#### **RPRC DETERMINATION LETTER**

Project Description:	Tree removal			
Street Location:	1 HUNTER DRIVE			
	Zoning District: R-1A Tax ID: 101.03-4-53.1	Application No.: 2021-0977		
RPRC DECISION:	RPRC - Requires Planning Board			
Date:	11/16/2021

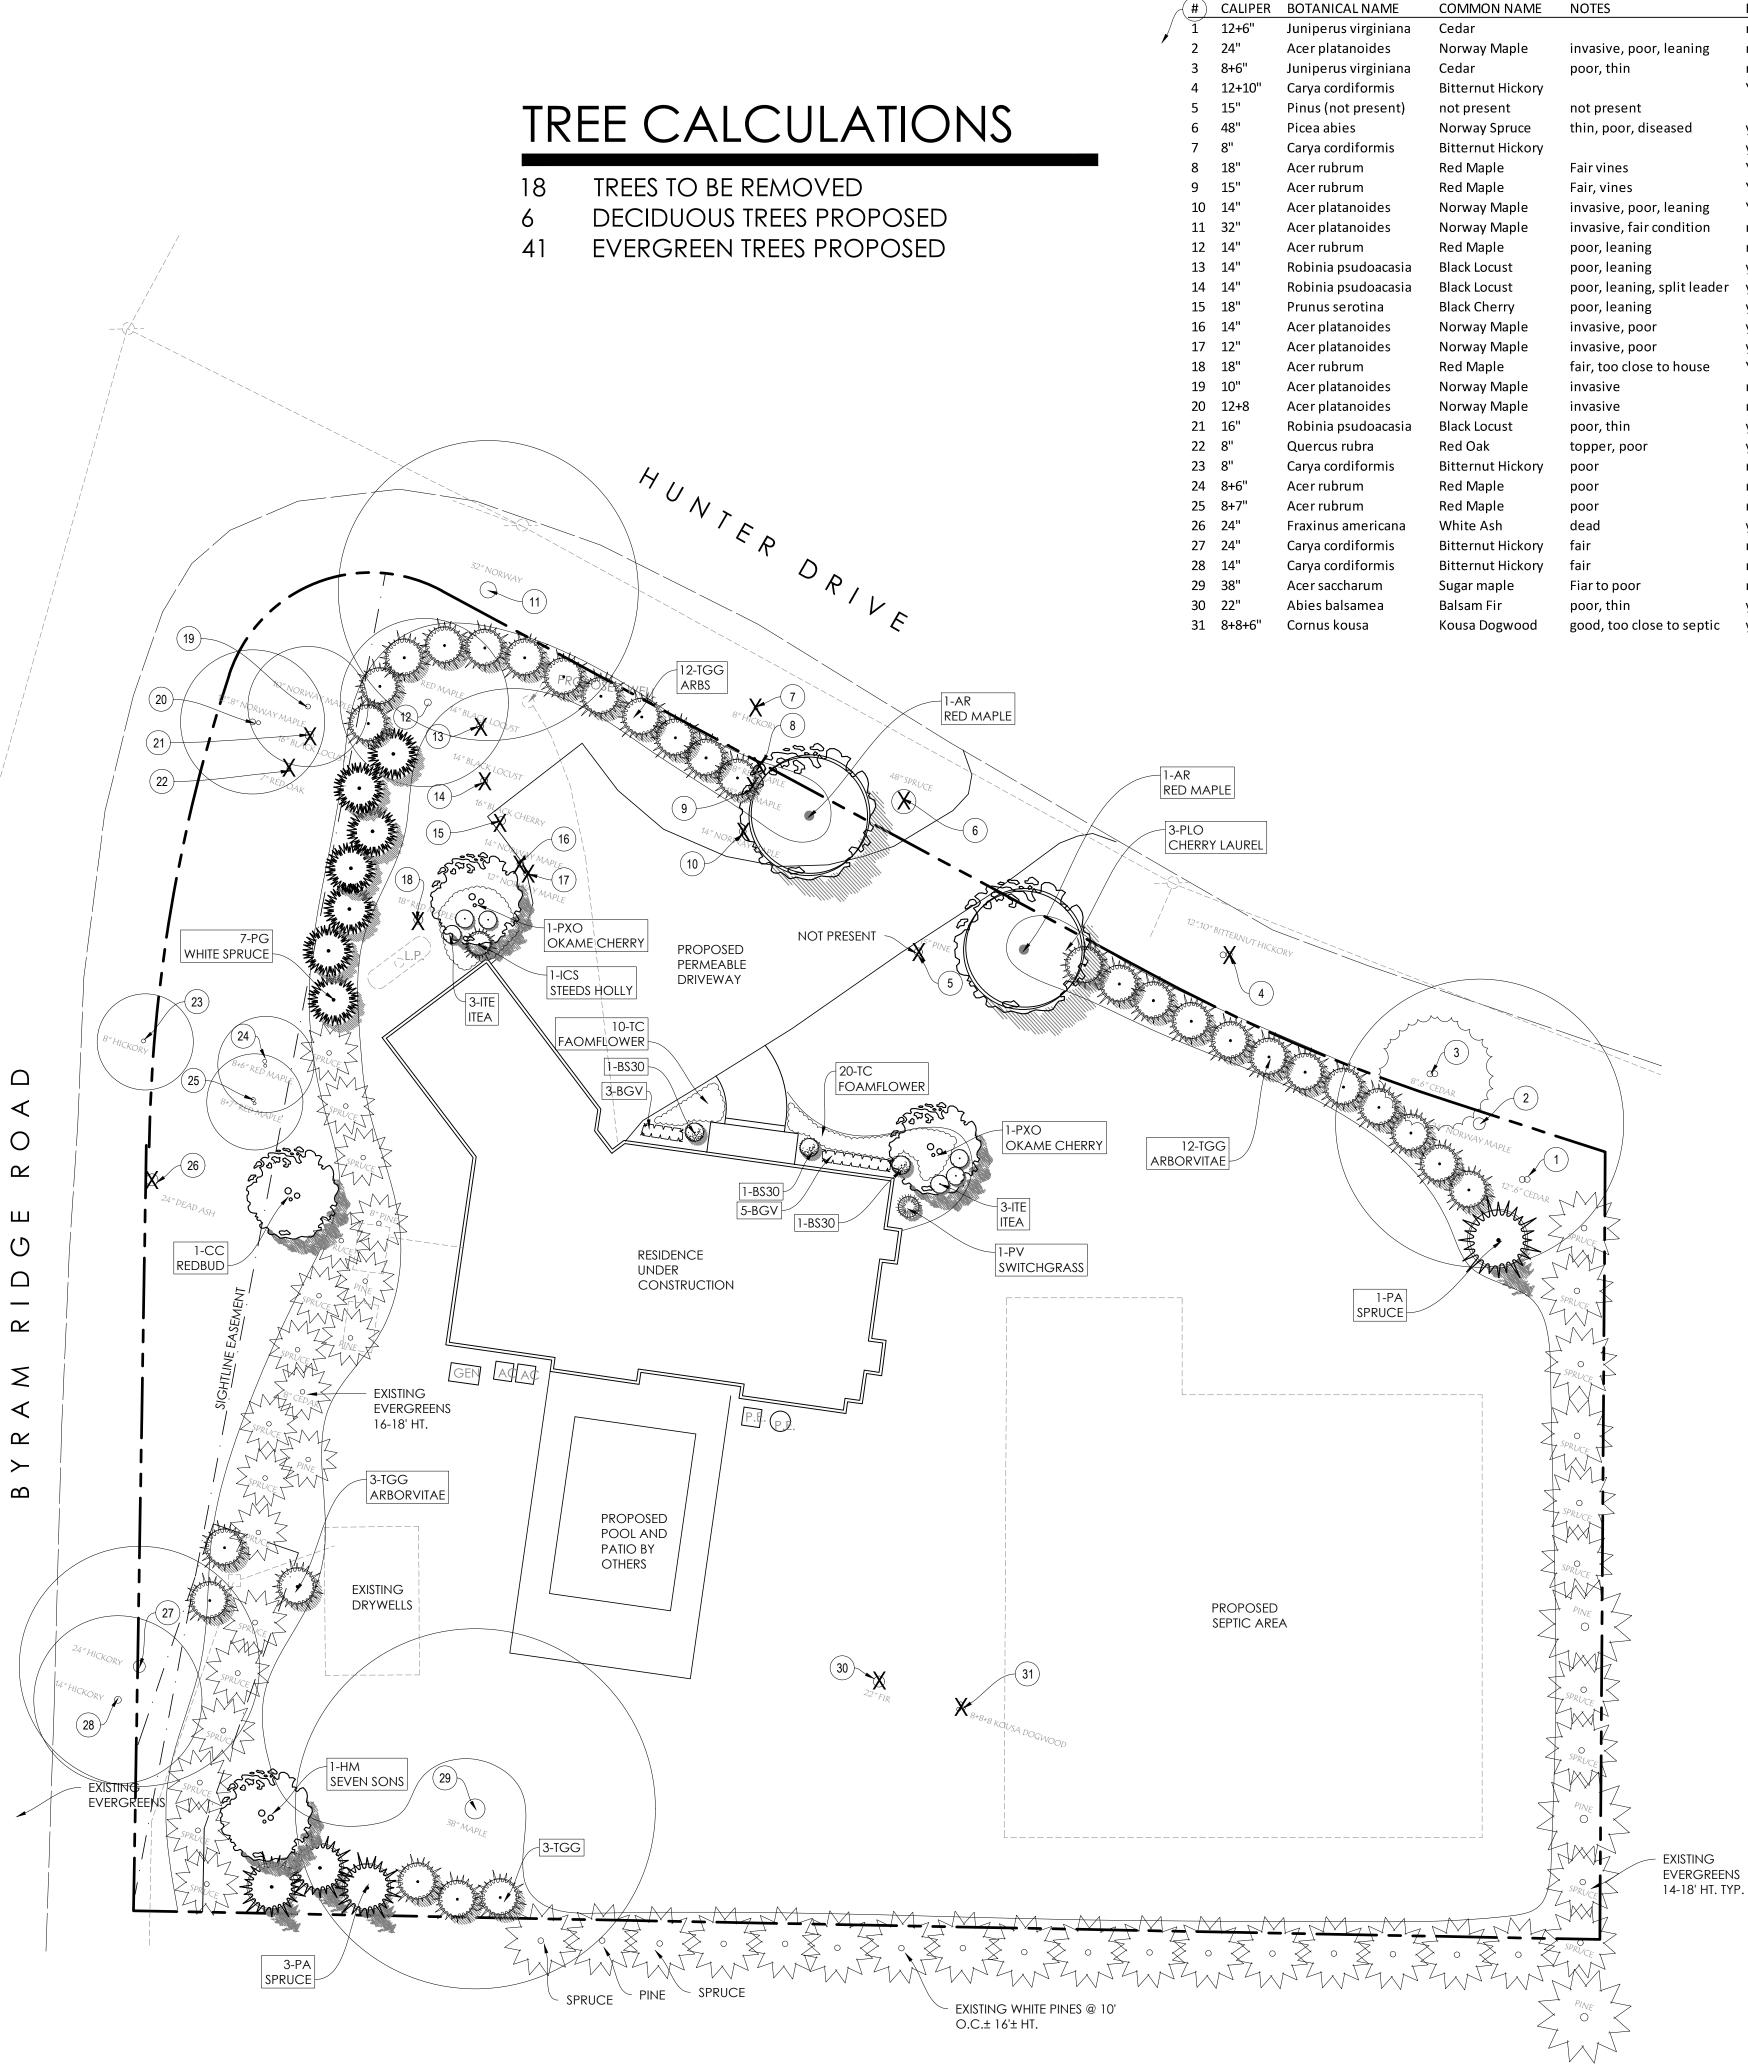
- The Applicant is proposing new evergreen screening along Hunter Drive and the rear yard of the house along Byram Ridge Road. New screening at the location of the proposed tree removal is limited.
- The Applicant should provide a plant schedule depicting the name, species, size and quantify of all mitigation/screening.
- It is recommended that the landscaping plan be revised to provide a more robust screening/revegetation plan.
